# Technical News

**SAILOR**

NUMMER 3

FEBRUAR 1995

## CONNECTION BOARD MODULE 6

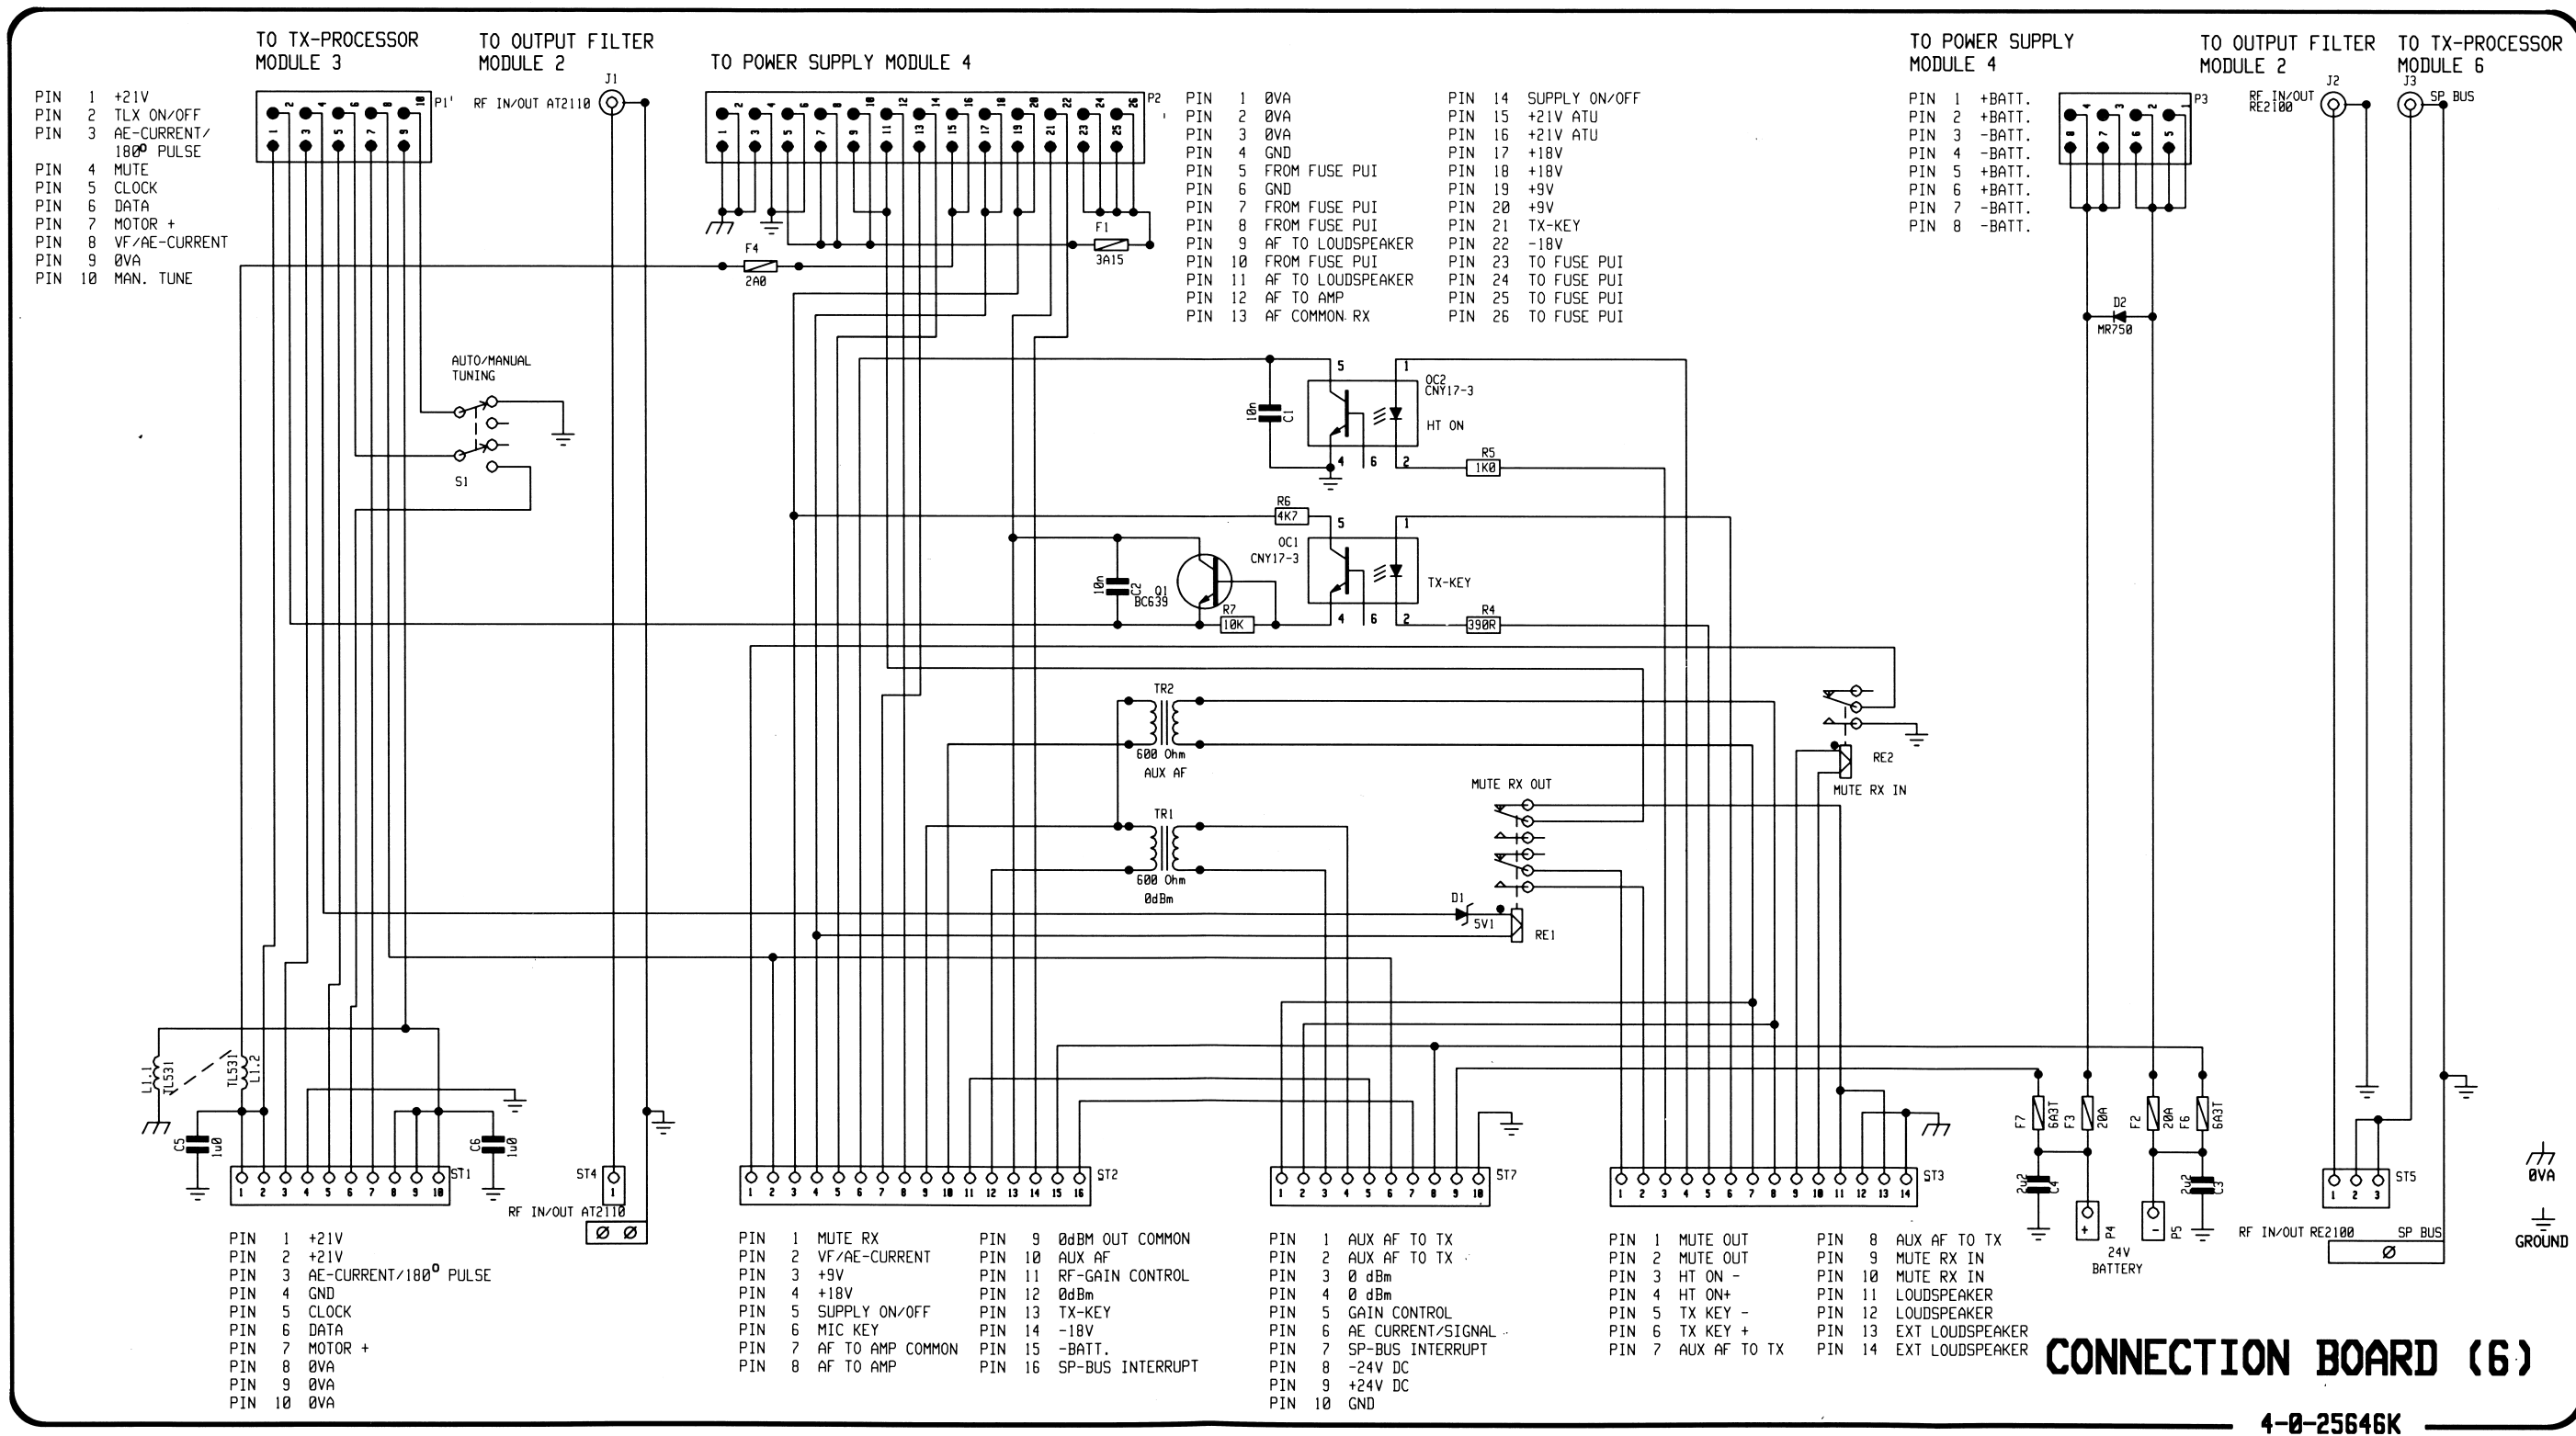
Det har været nødvendigt at indføre en ændring på connection board, da det, på grund af komponentspredning, ikke altid har været muligt at holde TX-KEY lav. Det er ikke nødvendigt at indføre disse ændringer i allerede leveret udstyr, da disse enheder er testet og i orden.

På connection board modul 6 er der indført en transistor Q2 ved OC2, således at dette kredsløb kan trække mere strøm. Moduler med denne ændring har version "H" eller højere. Denne nye version af connection board 6 kan anvendes sammen med alle versioner af TX-Processor modul 8.

CONNECTION BOARD MODULE 13

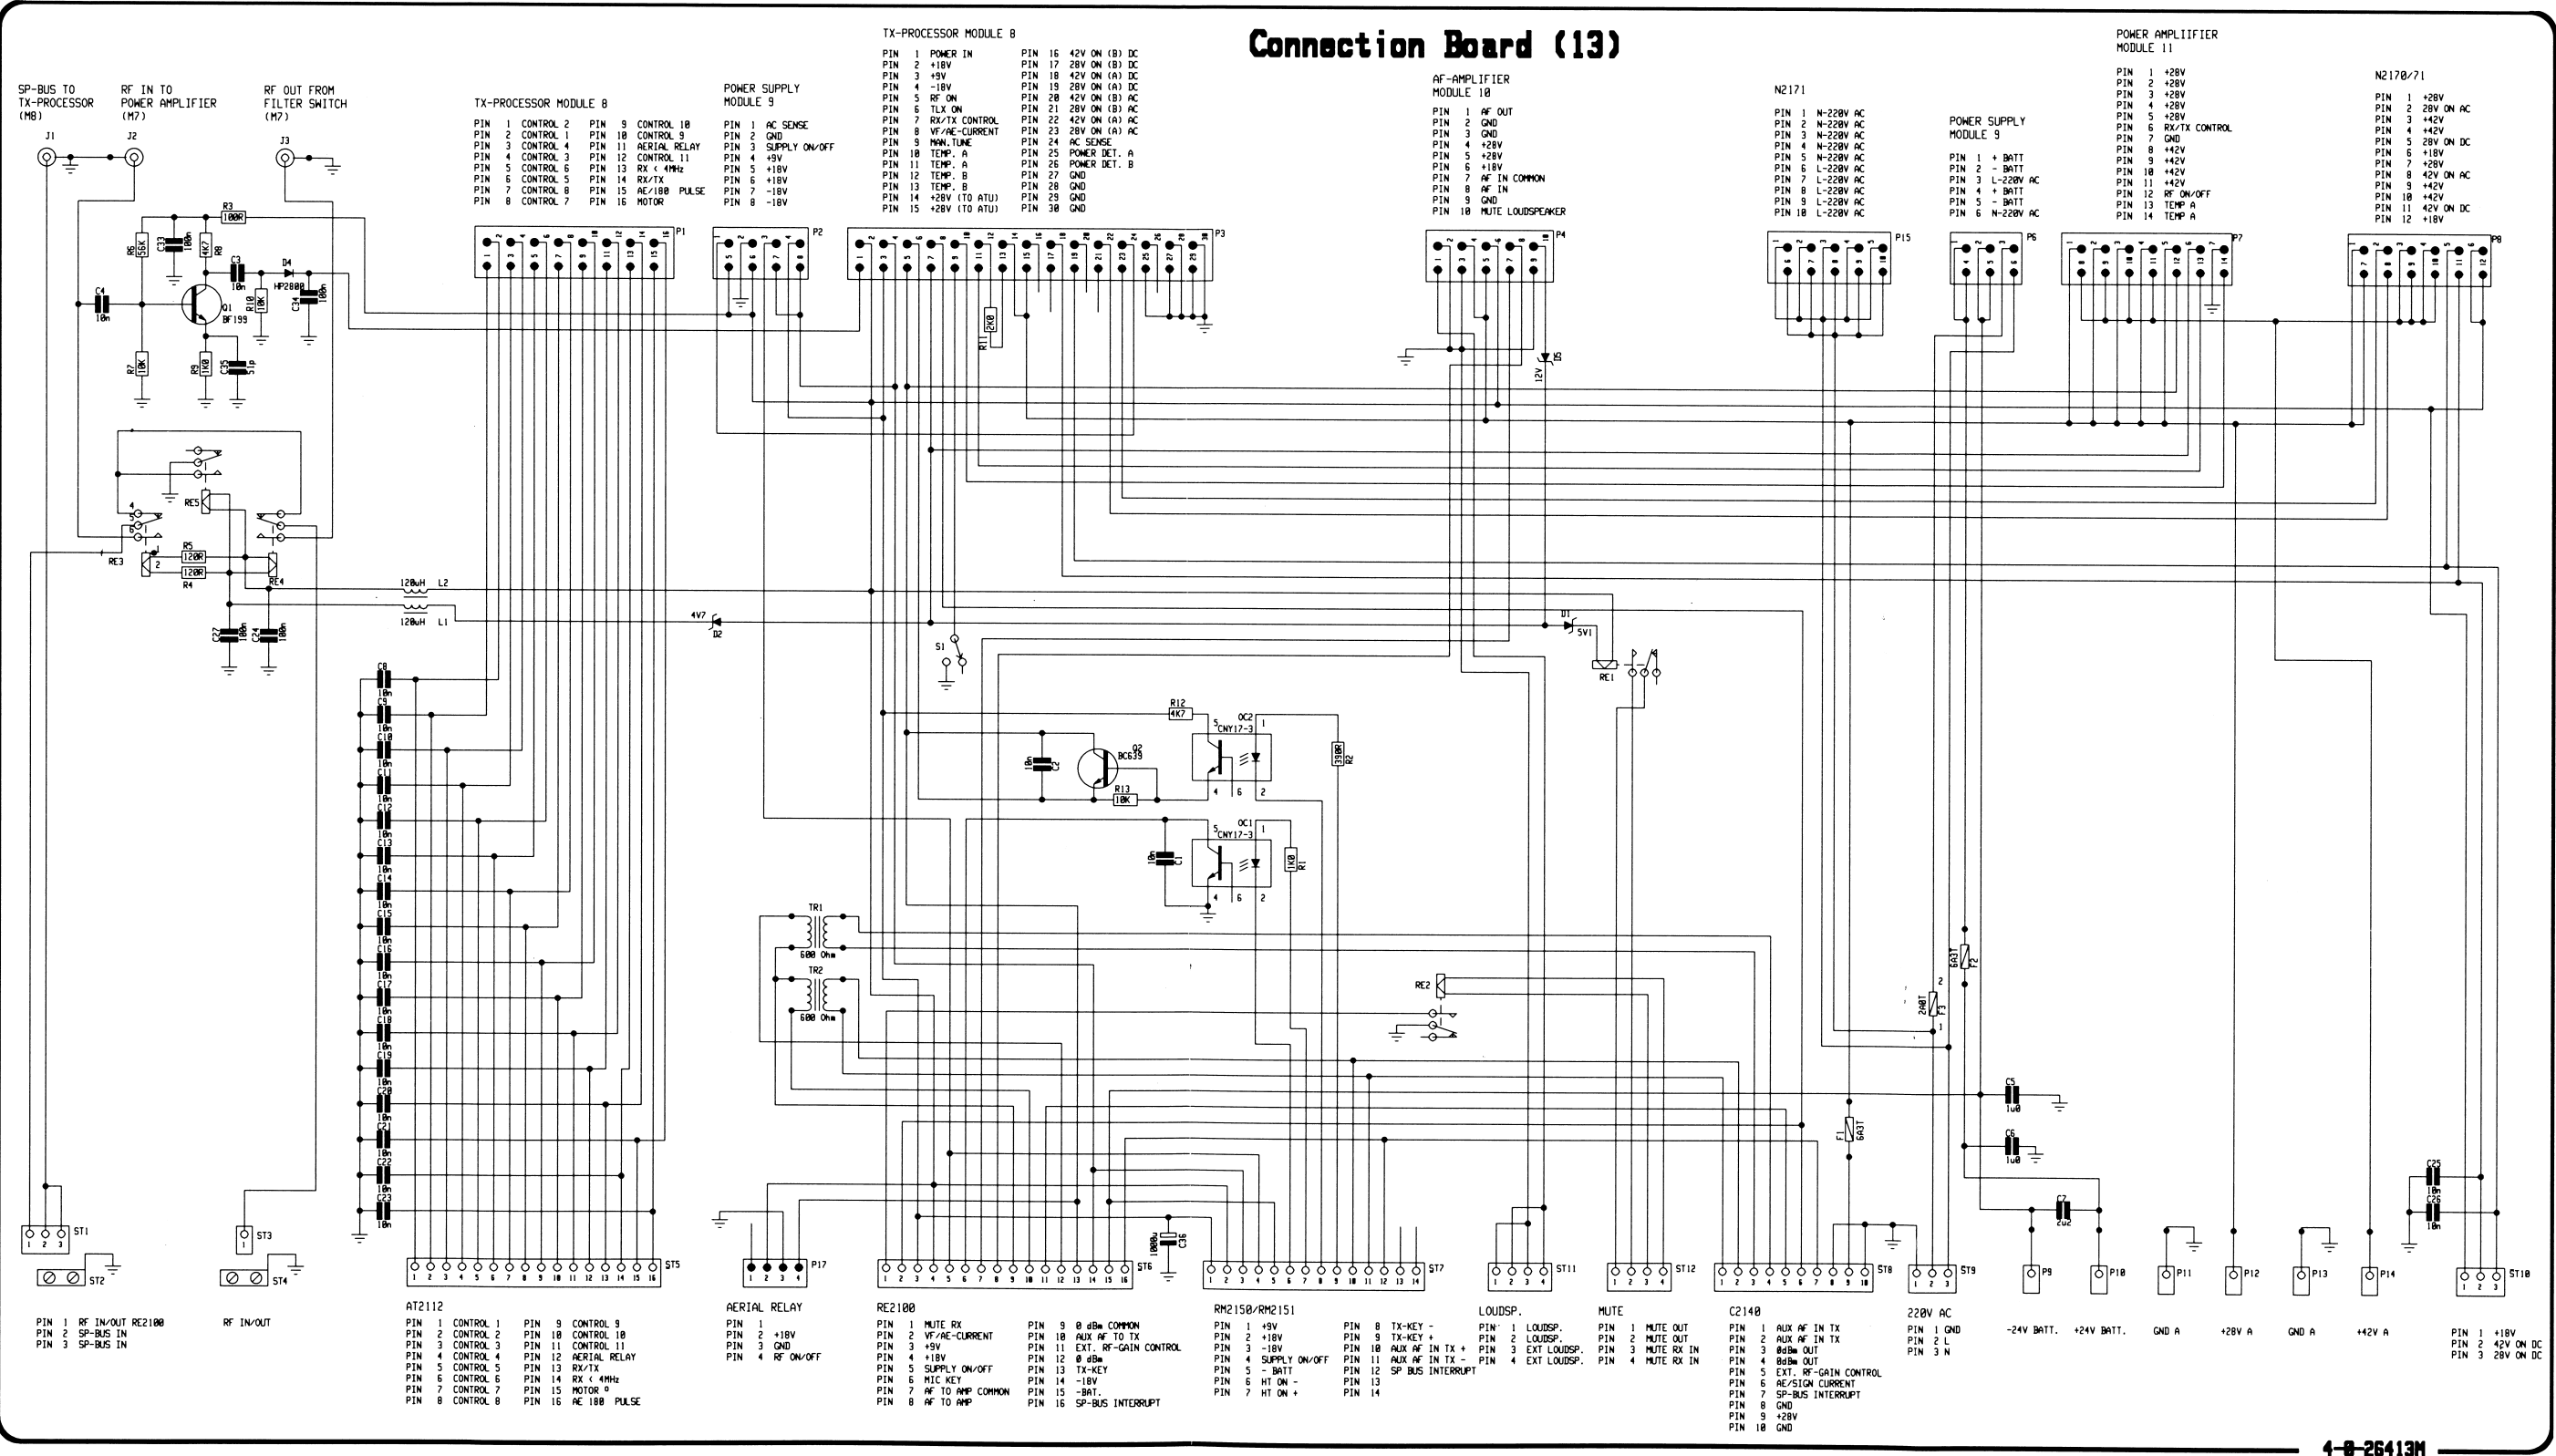
Det har været nødvendigt at indføre en ændring på connection board og processor board, da det, på grund af komponentspredning, ikke altid har været muligt at holde TX-KEY lav. Det er ikke nødvendigt at indføre disse ændringer i allerede leveret udstyr, da disse enheder er testet og i orden.

På connection board modul 13 er der indført en transistor Q2 ved OC2, således at dette kredsløb kan trække mere strøm. Moduler med denne ændring har version "N" eller højere. Denne nye version af connection board 13 kan anvendes sammen med alle versioner af TX-Processor modul 8.
